Access Compliance Report

Public Rights-of-Way

Intersection ID: 46343	Main Street: MEADOW_KNOLL_DR	Cross Street: STREAM_BANK_DR	Location: SE
ADA ID: CC53A3CE4D6D	Ramp Type: BlendTrans1	Initial Pass/Fail: Fail	Overall Compliance: No
		Severity Score: 47.5

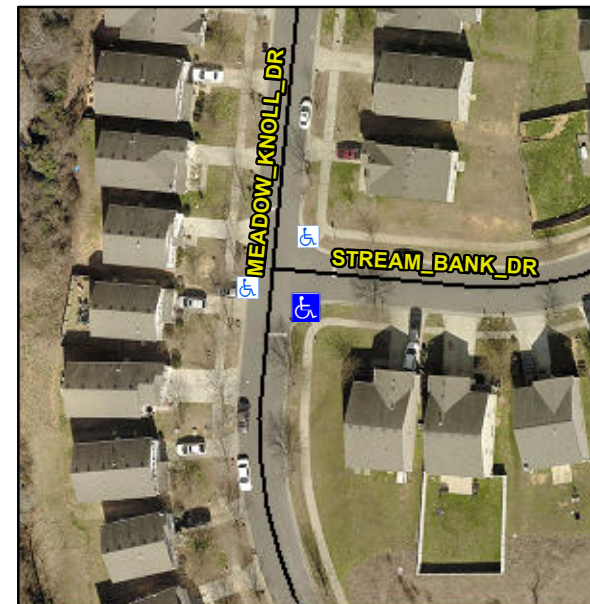
CURB GAP 1.0

Not Found, R304.5.1, R304.5.3

Remove & Replace Curb Ramp With Two New Directional Ramps or Equivalent.
